# Geotechnical Review Sheet

FILE NO. 11G-190

RE: Proposed Grading & Retaining Walls  
25 Estrada Place

**REPORT**  
**GEOTECHNICAL INVESTIGATION**  
**INCLUDING SLOPE STABILITY ANALYSIS**  
**AND GEOLOGIC HAZARD ASSESSMENT**

Figure 8  
**CROSS-SECTION A - A'**

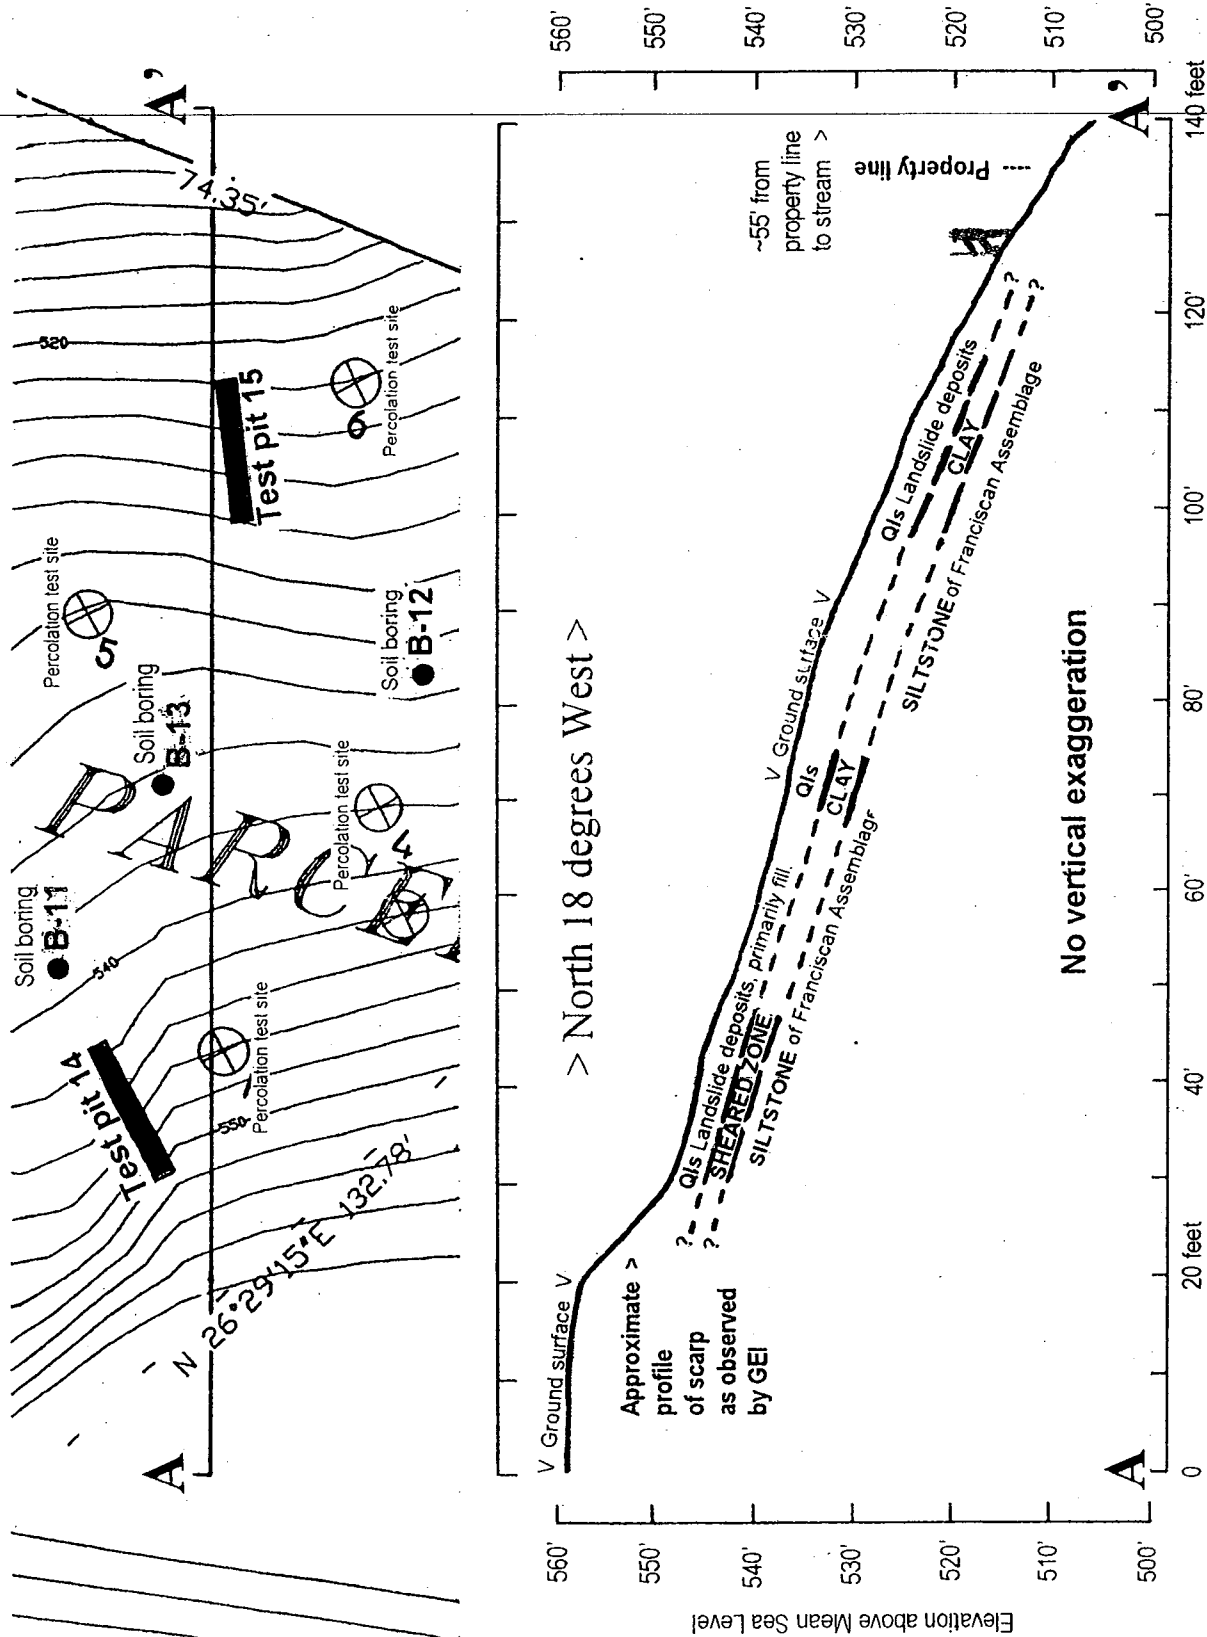
6. The slope stability analysis and cross-section assume that the existing landslide toes out evenly, without a bulge or deepening of material, in the drainage downhill and off this site. What evidence is there to support this theory? Please discuss.
